CDRL A004
Technical Report - Study/Services
Site Preparation Guide

Cargo Movement Operations System (CMOS)

This is a revision of a 4 Aug 89 document supplied by the CMOS PMO. The purpose of the revision was to clarify instructions and update information contained in the original.

SITE PREPARATION GUIDE

SYSTEM ADMINISTRATOR WORK CENTER

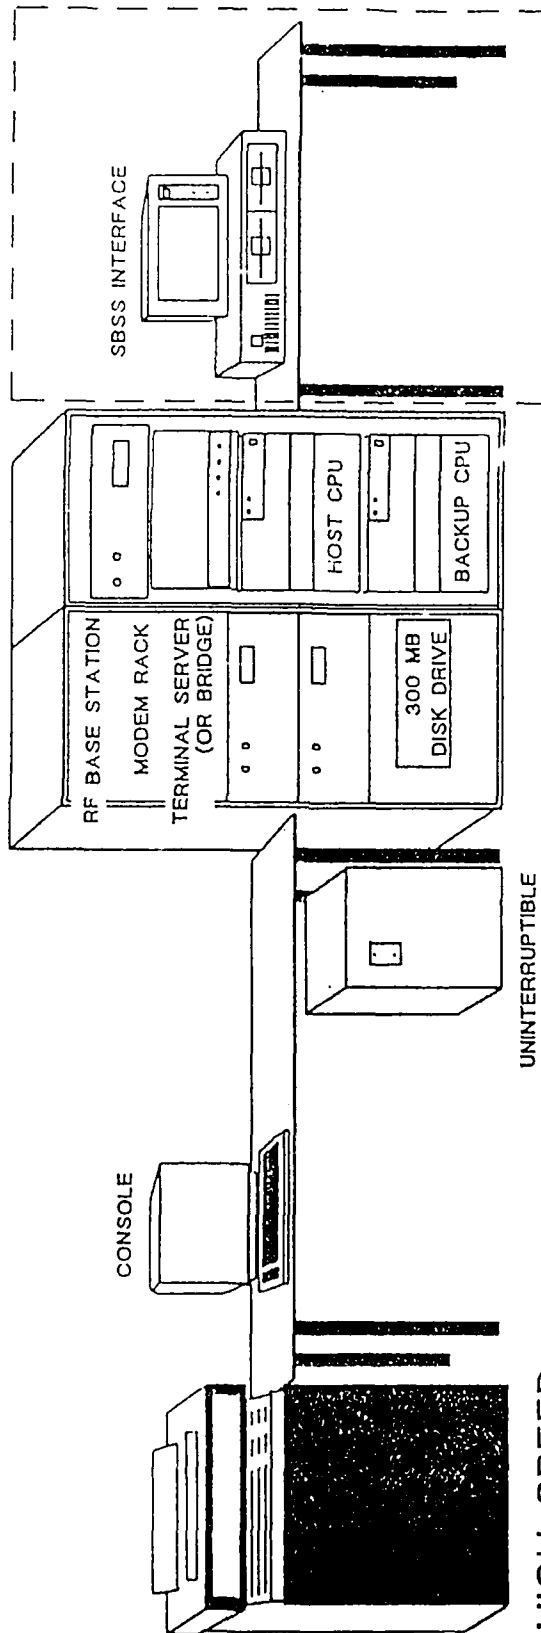
b. System Administrator workcenter diagram (Fig B-1) does not contain accurate information regarding the AT&T equipment. Cable lines are not drawn. If the SBSS interface changes to route through the DDN concentrator then this portion is not up-to-date.

TYPE A WORKCENTER LAYOUT

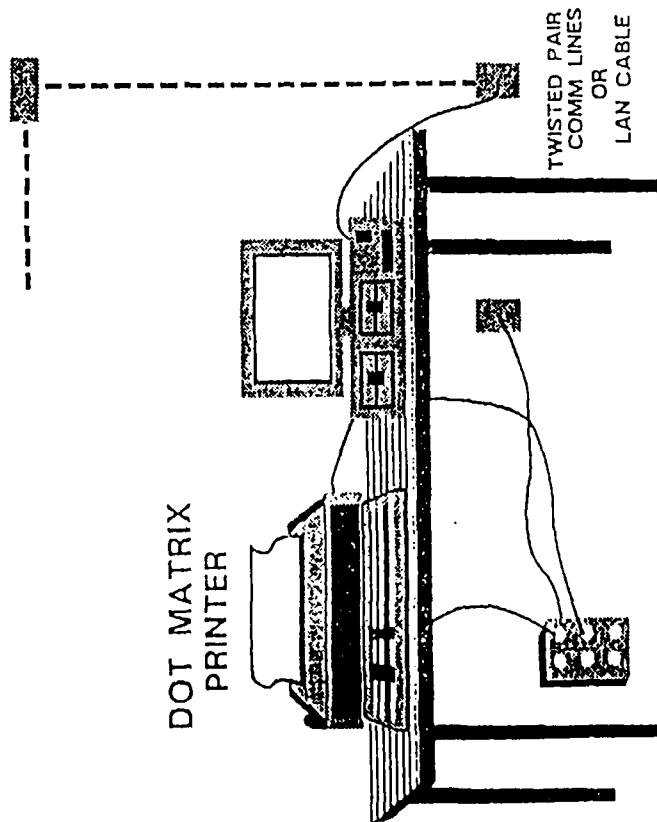
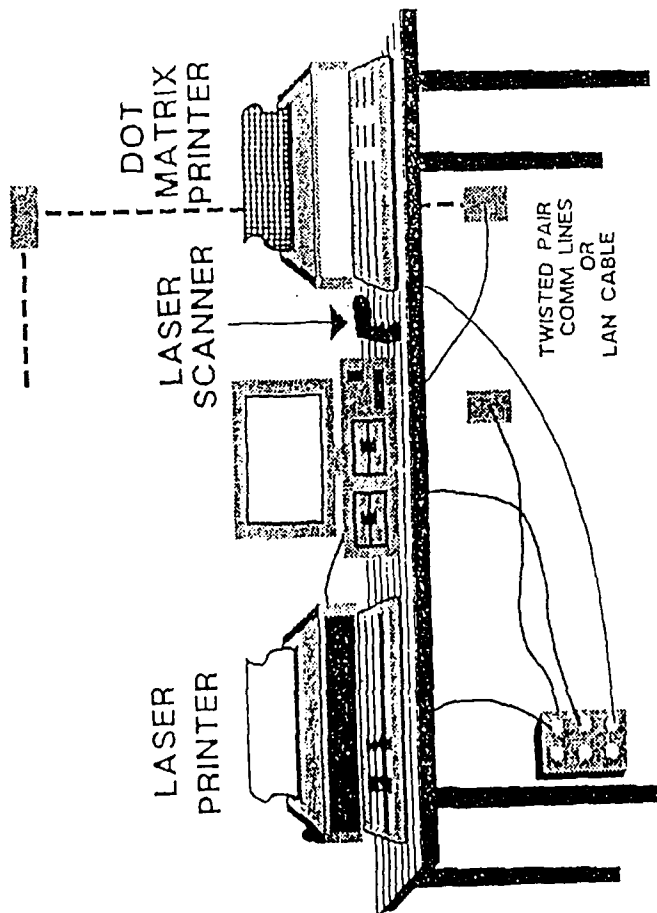
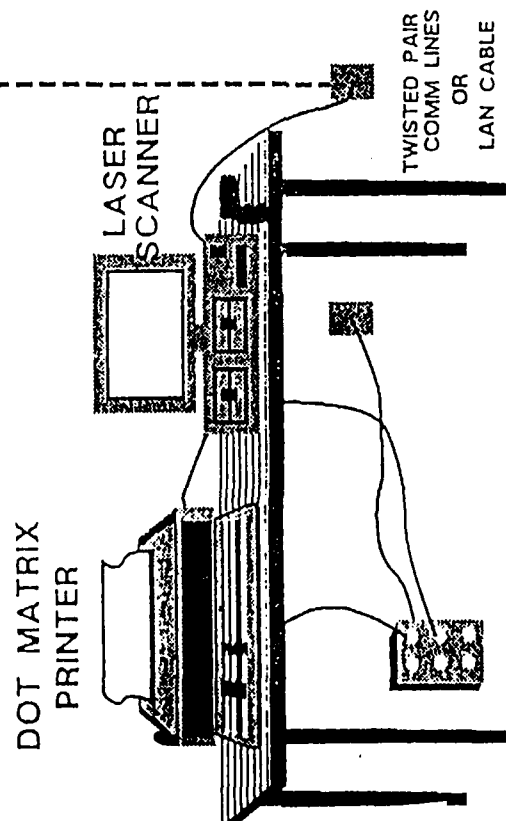
c. Type A, B, and C workcenters do not reflect the requirement for modems and some cables are not drawn.

CENTRAL PROCESSOR AREA (TMO CENTER) (120 VOLT, 60 HZ APPLICATION)

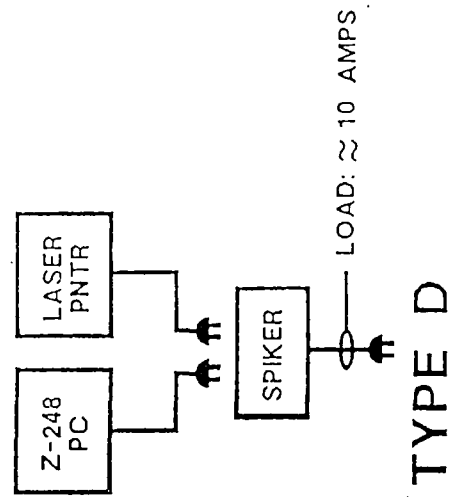
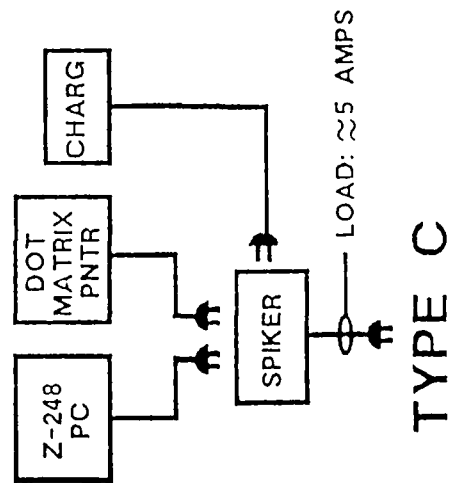
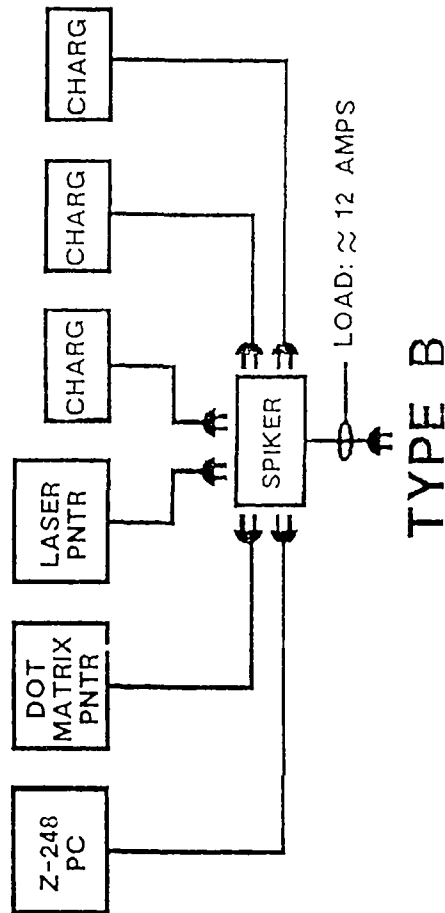
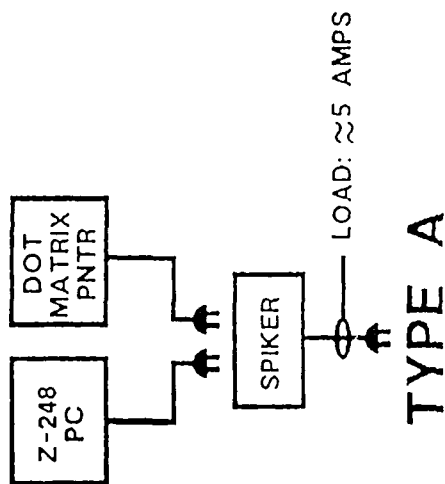
d. Electrical schematics show equipment, such as a lan bridge and streaming tape, which are no longer planned for various workcenters.
